PHOTOGRAPHS

PHOTOGRAPH #3

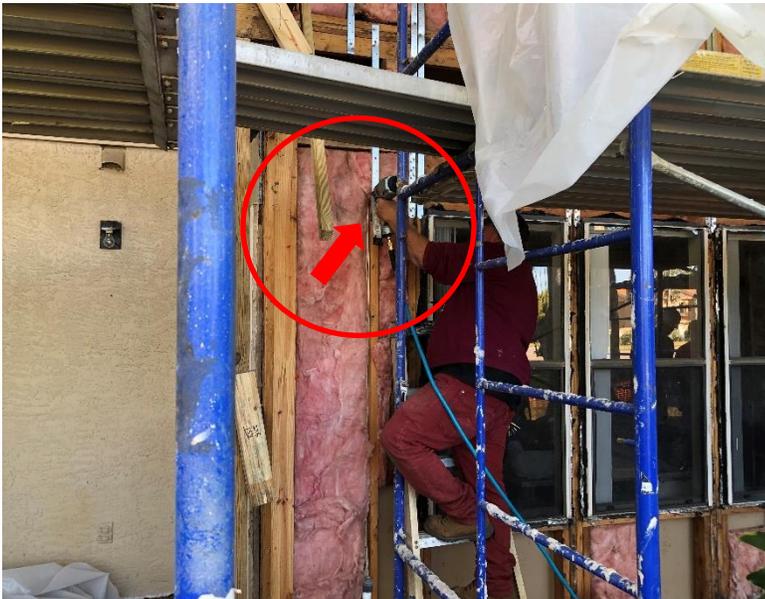
Contractor installed scaffolding in preparation of sheathing removal.

PHOTOGRAPH #4

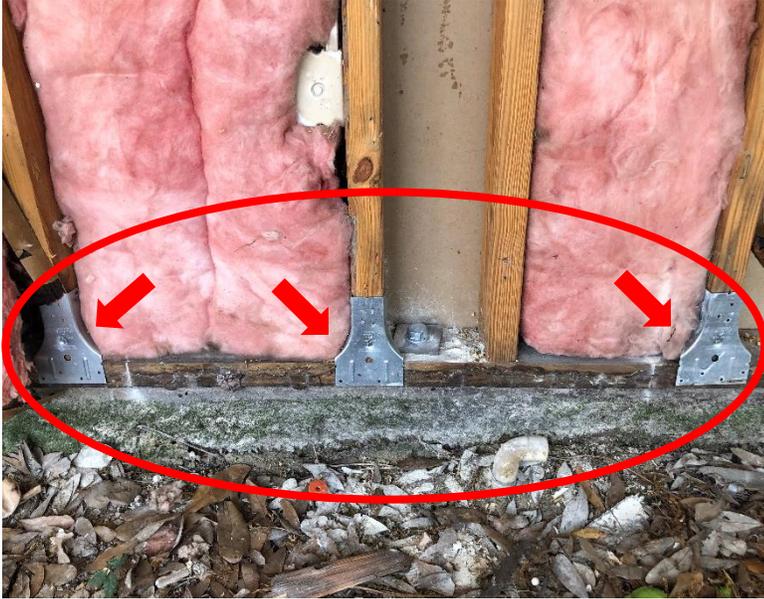
Contractor installing 10d nails at MSTA 36 Simpson Strong-tie connectors, as per drawings and specifications.
